MIL-F-15733/49G
AMENDMENT 3
15 March 1993
SUPERSEDING
AMENDMENT 2
10 August 1990

MILITARY SPECIFICATION SHEET

FILTERS AND CAPACITORS, RADIO FREQUENCY INTERFERENCE,
HERMETICALLY SEALED, STYLE FL93

FIGURE 1. Case dimensions and circuit diagrams - Continued.

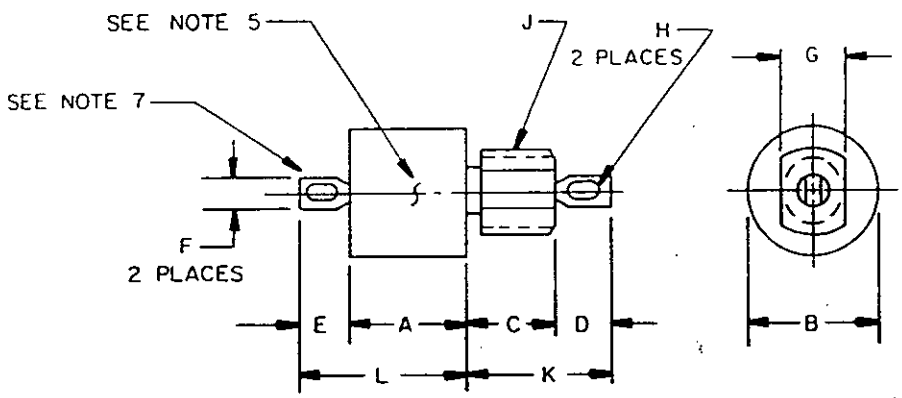
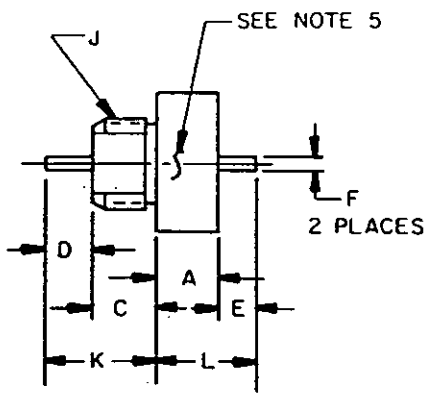
FIGURE 1, delete the figures for dash number "0007" and dash numbers "0002 through 0006, 0008, and 0010" and substitute:

DASH NUMBERS 0002 THROUGH 0006,0008,AND 0010

DASH NUMBER 0007
